EVALUATION OF THE WIPP PROJECT'S COMPLIANCE
WITH THE EPA RADIATION PROTECTION STANDARDS
FOR DISPOSAL OF TRANSURANIC WASTE

March 1998

FOREWORD

Figure 2. Overall Mean of Normalized Releases for Modeling of increased solubilities using Nesquehonite and ‘No Backfill’ Values compared to CCA values.

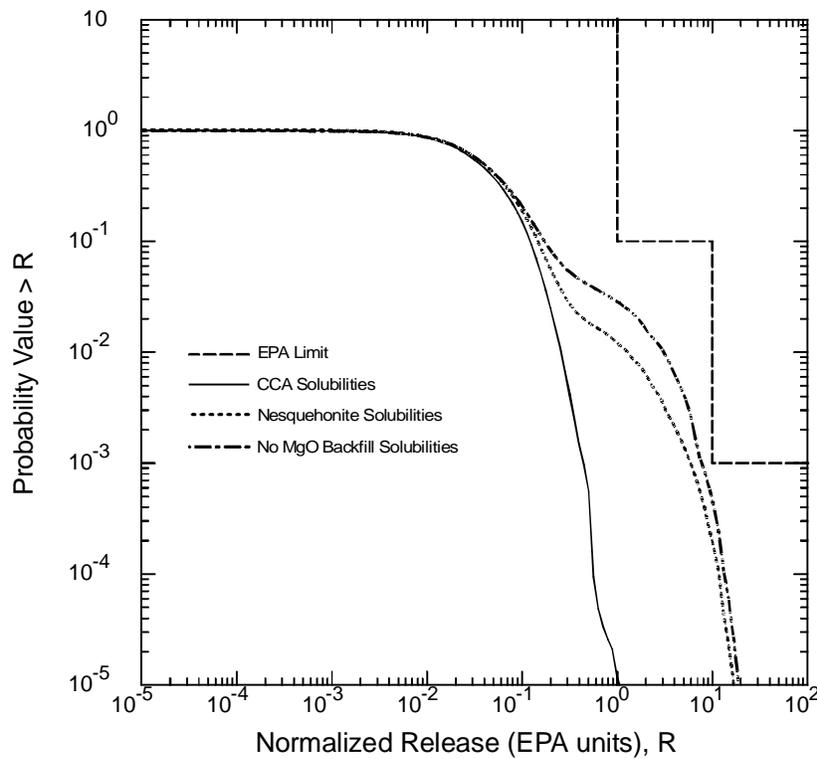
The results of running new solubility values can be seen in Figure 2. The figure shows the overall mean of all processes combined as they relate to compliance. In addition, the PAVT direct brine releases were run with the slightly higher CCA solubilities. The most distinct feature of the figure is the shoulder of the high solubility models that extend below the 10^{-1} probability limit. The “shouldering” is the effect of increased releases due to the direct brine release. Since the Pu+4 and Th+4 (although minor) solubilities increased over 5 orders of magnitude, the release due to this mechanism is expected to increase significantly as well. For example, the CCA median value for +4 actinide solubilities in Castile brine was 6×10^{-9} M. If one assumes 100 m^3 of Pu^{239} brine, then it is expected that the release is 2.5×10^{-5} EPA units. If the solubility is increased by $10^{5.23}$ as seen in Table 1., then it is expected that 4.24 EPA units are released to the accessible environment. Therefore, the CCDF for higher solubilities would be closer to the EPA limit.

The consequences of higher solubilities, as seen in Figure 2 are quite high. The overall mean

Figure 3. Contiguous Failed Volume as a Function of Increasing Waste Permeability for Different Waste Strengths With Initial Repository Pressure of 14.5 MPa.

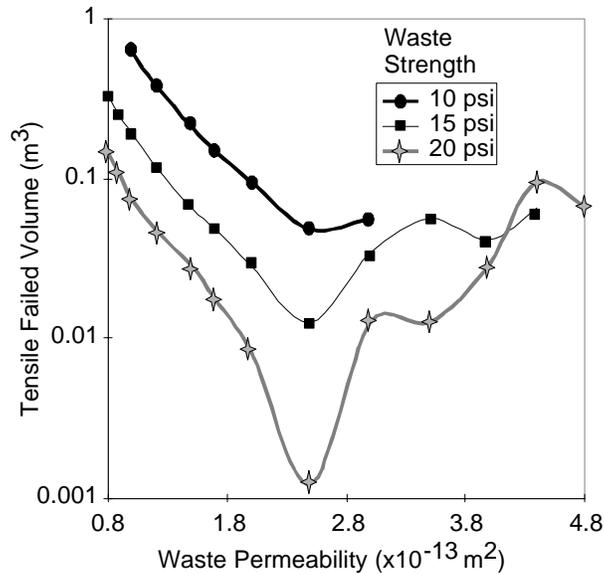
The reported failed volumes outside the range for the Base Case are extremely high, resulting in as much as 22.5 m^3 for a permeability of $0.5 \times 10^{-13} \text{ m}^2$ due to the cascading affect of multiple zone failure. The geometry of the borehole cavity was discretized and solved on a hemispherical coordinate system. The layers of the hemisphere were kept to a minimum (0.01 meters) to avoid instability. When the waste in the borehole fails, it is assumed that the whole layer fails, and peels off like an onion skin. When the code calculates a large failed volume, as in the case with $0.5 \times 10^{-13} \text{ m}^2$ permeability, the effect is several layers peeling off in one time step, cascading until an equilibrium is reached with the high pressure gradient that existed at a longer time period. It is assumed that when the cascading effect is exhibited, the results become meaningless.

Figure 3 shows some interesting results as the waste permeability increases. All the waste strengths tested showed an exponentially decreasing failed volume, up to a permeability of $2.5 \times 10^{-13} \text{ m}^2$. Permeabilities above this value cause larger failed volumes than values below it. The upper limit on permeability shows that the code is reliable to $2.5 \times 10^{-15} \text{ m}^2$ for waste strengths that were measured in the report by Hansen et al. (1997) and initial repository pressure of 14.5 MPa. The lower permeability limit is $1.0 \times 10^{-13} \text{ m}^2$ for 10 psi waste strength, and decreases to $0.8 \times 10^{-13} \text{ m}^2$ for waste strengths of 15 and 20 psi.

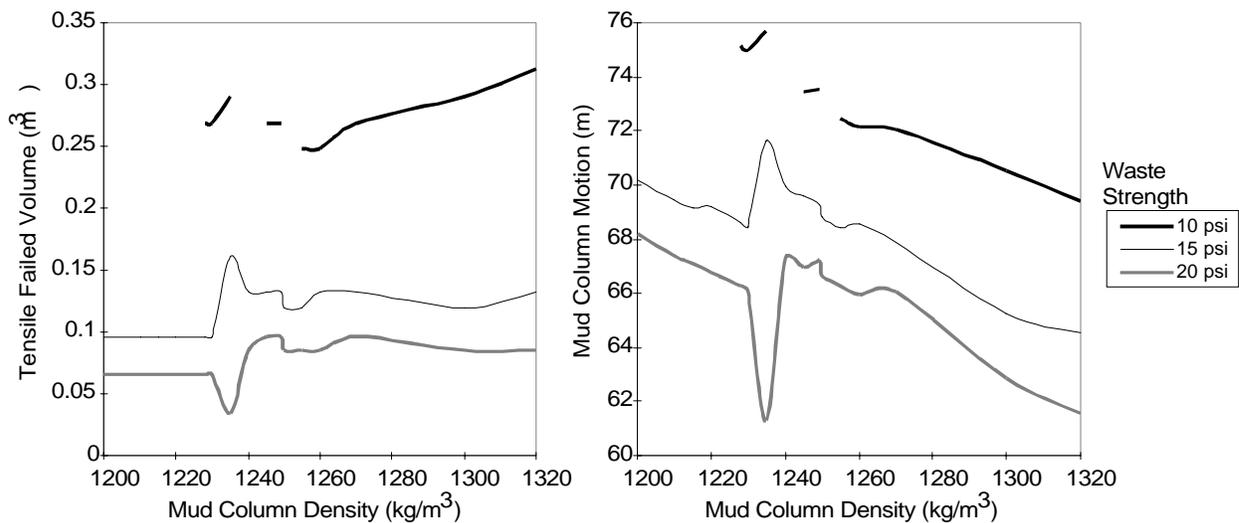
Figure 4 shows the results of varying the parameter from 1200 to 1320 kg/m³ for a 10 second simulation and an initial repository pressure of 14.8 MPa. The figure shows three curves of different waste strength, with all other parameters remaining the same as used in the Base Case simulation. The most outstanding feature of Figure 4 is the disjointed curve of failed waste (left) and mud motion (right) of the 10 psi tensile waste strength simulation. The code had trouble calculating failed waste for mud densities below 1228 kg/m³, resulting in the cascading affect described above. The code also had trouble at 1240 and 1250 kg/m³, and if results were plotted for these densities (failed waste and mud motion), sharp spikes would exist in the curve.

For the higher waste strengths (and subsequently lower repository pressures) of 15 and 20 psi, the mud density simulations were able to calculate failed volumes for all density values investigated. However, the results seemed almost as unreliable as the lower waste strength. Though a trend can be seen in the failed volume and mud motion, variances from those trends are high. Both graphs in Figure 4. show trouble with densities between 1230 to 1270 kg/m³.

Figure 7. Failure Volume (m^3) vs Time (s) for Different Waste Permeabilities. The results are from GASOUT with the option of ‘failed material removal’ turned off.

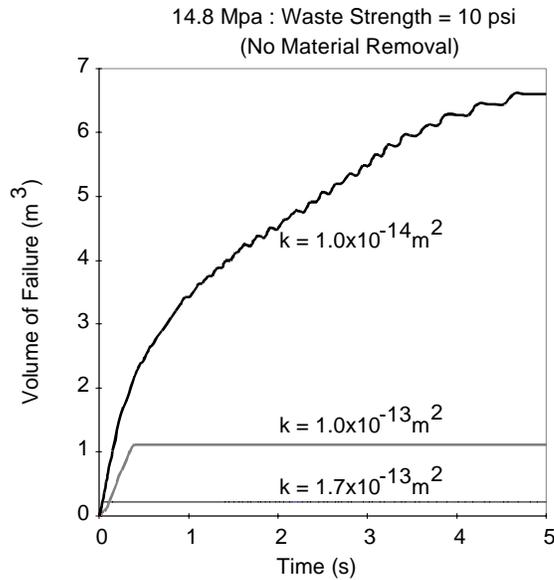
For an extreme example of the above analogy, Figure 7 shows radial distance of potential failure at permeabilities of 1.7×10^{-13} and 1×10^{-14} m² for pressures at 14.8 MPa without material removal. Potential failure was extrapolated from the effective stresses that would exist in non-failed material. The repository pressure was set at 14.8 MPa and waste strength at 10 psi for the experiments in Figure 7.

The figure clearly shows that when permeability is lower than assumed in the CCA then releases will be higher than assumed from the investigation in Hansen et al. (1997). The maximum radial failure at a permeability of 1×10^{-14} m² is 1.17 m, equating to an uncompacted spalled volume of 6.6 m³. It is believed that when permeability is even lower than the lowest value presented in Figure 7, the releases could be higher. However, the code has difficulties with oscillations in pressures at lower permeabilities, and confidence in results is low.

The results of Figure 7 must be kept in context. When material is not removed during the pore pressure calculations (and subsequently total overburden stress), the code does not redistribute values at the new boundary. Instead, the pore pressures decrease in that region, hence lowering the possibility of new failed material. Therefore, Figure 7 actually underestimates the potential effect of failure, and higher volumes will result if the material is removed. These calculations are not possible with GASOUT, with reasons explained from the sensitivity analysis with the code.

Figure 11. Effective Radial Stress As A Function Of Radial Distance For The EPA's Air Drilling Analysis.

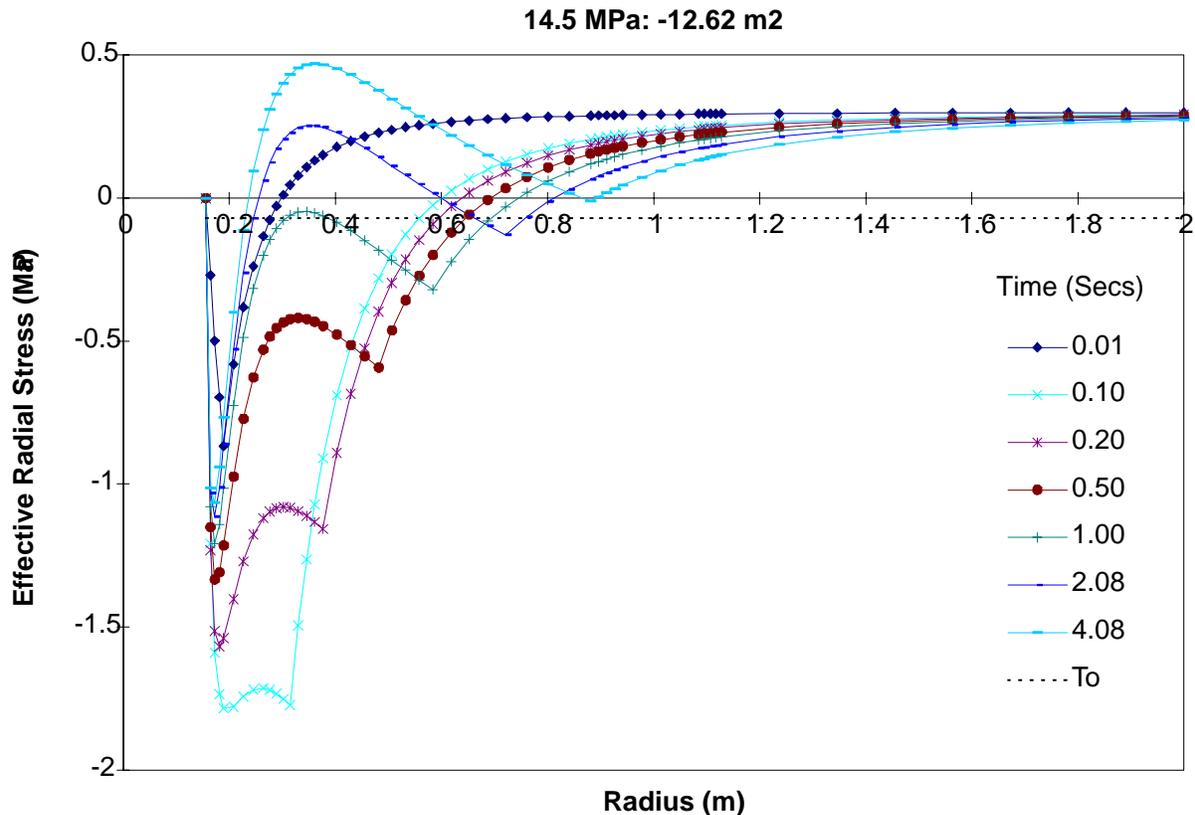
The results of air drilling from the EPA's analysis at WIPP is reproduced here in Figure 11. The figure shows effective stress versus radial distance within the repository at several times during the simulation. The EPA judged failure in this figure by estimating the point at which the effective stress is less than the strength of the material (indicating high pore pressure). This point is at 1 second from the beginning of the simulation, with a radial failure distance of 0.69 m (1.4 m³ of uncompacted waste). After 1 second of simulation time, the pore pressure in the waste near the cavity begins to decrease, and the effective stress moves upwards (increases positively) towards the region of higher total stress.

Intuitively, the results shown in Figure 11 would raise questions about the behavior of the system. Why does the effective stress sharply decrease from 0.01 seconds to 0.1 seconds then gradually rise throughout the remainder of the simulation? Does the system stop predicting failure after 1 second? What is the effect of tangential stresses in the waste? How does the system respond to varying repository parameters? All of these questions are relevant to the understanding of the Quasi-Static model and to the prediction of stresses in the waste from an air drilling event.

Figure 12. Effective Stress, Total Stress, and Pore Pressure Profiles in the waste at three independent times from the EPA’s Analysis of Air Drilling.

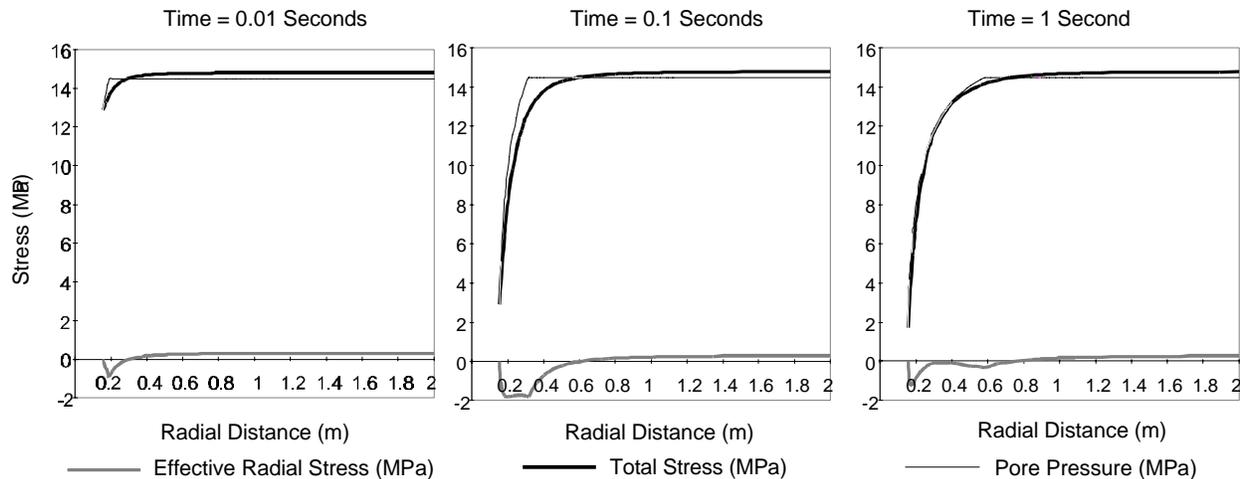
The effective stress is simply the difference in the calculated total stress and calculated pore pressure. Figure 12 shows the relationship between these quantities for three separate times for the EPA's analysis of air drilling. The left plot shows the first time step, at 0.01 seconds from time of intrusion. One can see immediately that waste failure occurs due to a slightly higher pore pressure, with the radius of failure being 0.27 m. The relatively large failure at this time is due to the unsmooth function of the pore pressure in the waste, which carries over to the effective stress. The same can be seen the two other plots of 0.1 and 1 second from intrusion time. The effects of the unsmooth pore pressure profile average out as the time from intrusion increases, but is one the reasons for increase in effective stress at later times.

The code also only approximates the pore pressures in the repository by assuming steady flow. As seen in Figure 12 (above), the steady flow assumption causes the pore pressure profile to be unsmooth. This characteristic, when combined with total stress of the overburden rock, produces oddly varying effective stresses in the waste. This shows that the code produces unreliable results for an air drilling scenario. When effective stresses are compared to the results of a code that calculates the time-dependent flow and pore pressures (Figure 13, above), the effective stresses are much lower (higher in the negative direction) than the Quasi-Static model at early times. Beyond the first couple of time steps, the code starts to be less accurate, and pore pressures begin to decrease in waste that should have been removed.

Figure 13. Effective Radial Stress As A Function Of Radial Distance Using GasOut For The Air Drilling Analysis.

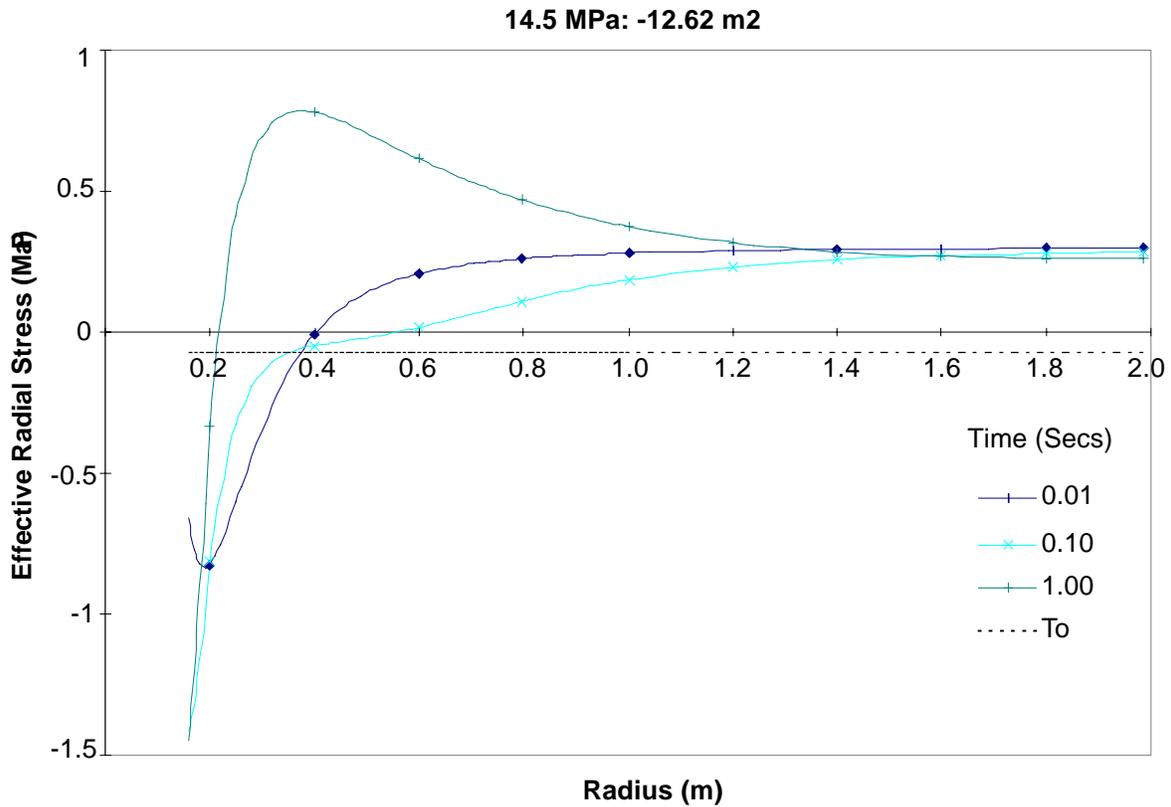
Though the difference in pressures between the two curves is slight, it would have a significant impact on the effective stresses and potential releases. For Figures 1 and 3 above, the pore pressures artificially decrease from the flow of gas in material that should have been removed. Therefore, the judgment of waste failure from Figure 11 leads to false confidence by underpredicting waste failure.

Figure 14. Yield Potential for EPA Air Drilling Analysis. The Figure Represents Equation 2 (above) vs. Radial Distance. Yield Will Occur When the Potential is Greater than Zero.

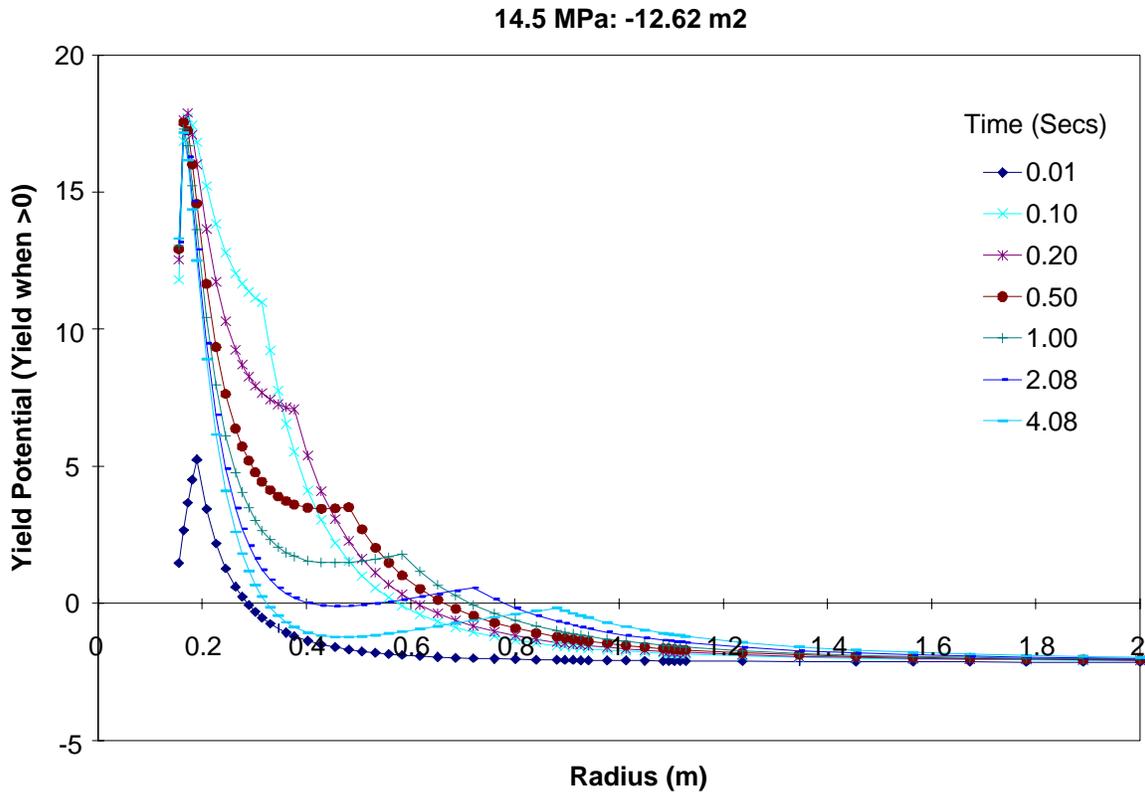
Figure 14 shows the results of Equation 2.5-2 plotted against radial distance. The first observation is that there is potential for yield out to 2 seconds from the time of intrusion. The yield crosses the axis at approximately 0.8 m, resulting in an uncompacted volume of 2.1 m³. This is an increase of 33% from the initial estimate stated in the EPA's analysis. The curves also seem to be highly influenced by the discontinuity in pore pressure calculations, and can be seen in Figure 14 by the second peak in the curve as radial distance increases. When compared to the yield potential calculated from GasOut, which calculates a smooth function of pore pressure, the limit for yield is 0.7 m at 0.1 seconds from intrusion (as compared to 0.6 m from the Quasi-Static model). After this time the yield is essentially zero.

Figure 15. Effective Radial Stress As A Function Of Radial Distance For An Increased Pressure For The Air Drilling Scenario.

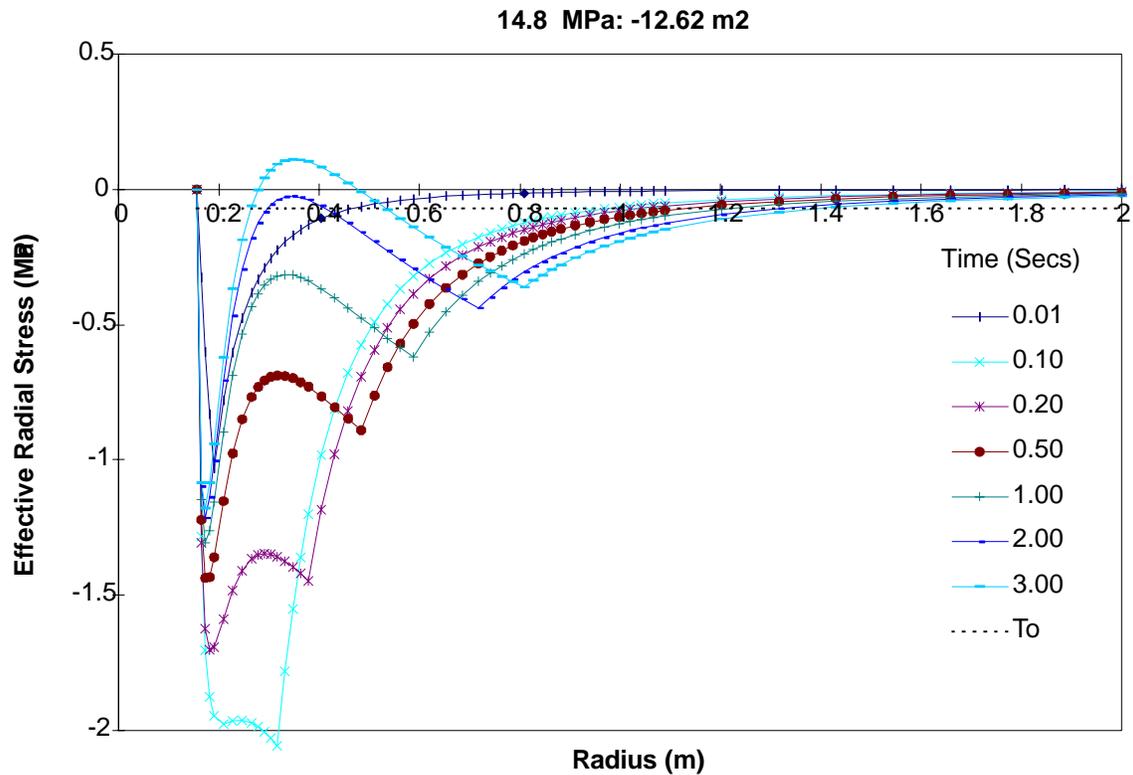
To demonstrate the response of the model to different input assumptions, Figure 15 shows a simulation in which the repository is increased from the nominal 14.5 MPa that was used in the EPA analysis to 14.8 MPa. The higher pressure is the maximum pressure that the repository will

sustain for long periods of time, and is the lithostatic pressure of the overburden rock. If gas pressures are above lithostatic, the weak stratigraphic layers will fracture until sufficient energy is released and the pressure returns to the minimum fracturing pressure. The results of Figure 15 are astounding. The figure shows that a nominal increase in pressure will significantly increase potential releases. At 1 second after initial intrusion, the radial distance of failure is 1.22 m (7.58 m³ of uncompacted waste). Although not shown, the waste will continue to fail during the entire 9 second simulation, in which the radial distance increases to approximately 1.65 m (19.1 m³ of uncompacted waste). These volumes are greater than the 4.0 m³ maximum calculated in the CCA, and perhaps would have an impact on the CCDF calculations if air drilling scenarios were considered in the CCA.

Fig. 19. Comparison of Approved Injection Pressures For Salt Water Disposal Well Versus Oil Field Water Flood Wells Near WIPP.

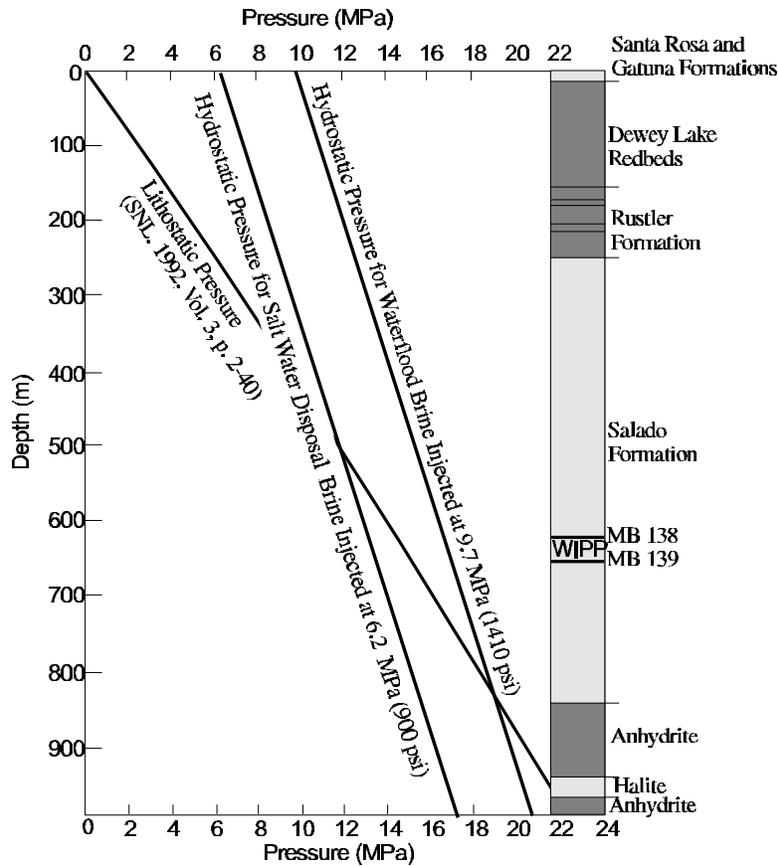
WIPP. Figure 19 compares the maximum approved disposal pressure for two wells one mile to the east of the WIPP Site. EEG is not suggesting that either of these wells are leaking. But EEG notes that in the event of a leak near WIPP current approved salt water disposal pressures are not sufficient at the repository horizon to exceed the lithostatic pressure. Only a leak in the waterflood well would be of concern to the repository. This is an inherent result of the greater vertical distance to the oil producing horizons. The DOE and EPA rationale appears to be more appropriate for the more shallow oil and gas reservoirs in the Vacuum Field area and the Rhodes Yates area and not suitable for the WIPP area. Presumably, carbon dioxide for enhanced oil recovery would be injected into the deeper oil producing zones and at sufficient pressures to maintain a miscible displacement. Hence, given the observation above, EPA can not conclude that the salt water disposal well analyses captures the CO₂ flooding scenario.

Fig. 20. Solution Mining of Brine and Natural Gas Storage Wells.

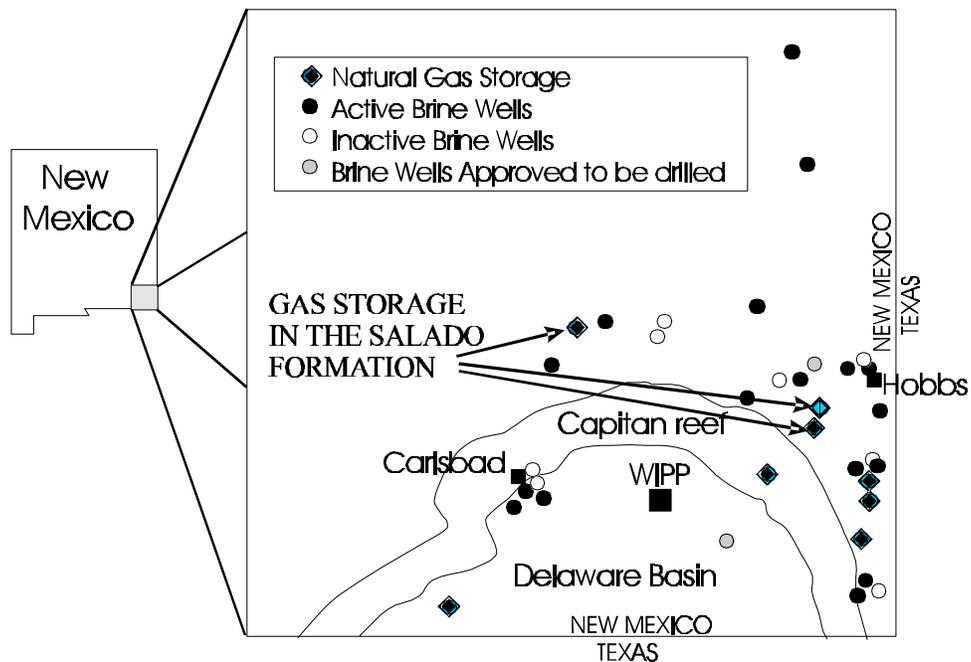
As shown in Figure 20, there are three solution mining operations for brine production near the city of Carlsbad area and at least 16 miles from the WIPP site. EPA mentions only one about 14 miles from the WIPP Site. Furthermore, EPA does not discuss the trend towards drilling brine production facilities closer to WIPP. Brine well BW-26 has been approved for production from the Salado Formation. The solution mining operation would be located between Jal and Carlsbad to meet the demand for drilling brine. The well was approved to remove salt from the Salado formation which lies between 1500 to 2300 feet deep. The subsidence calculations provided by DOE were for a facility that is 583 feet deep.
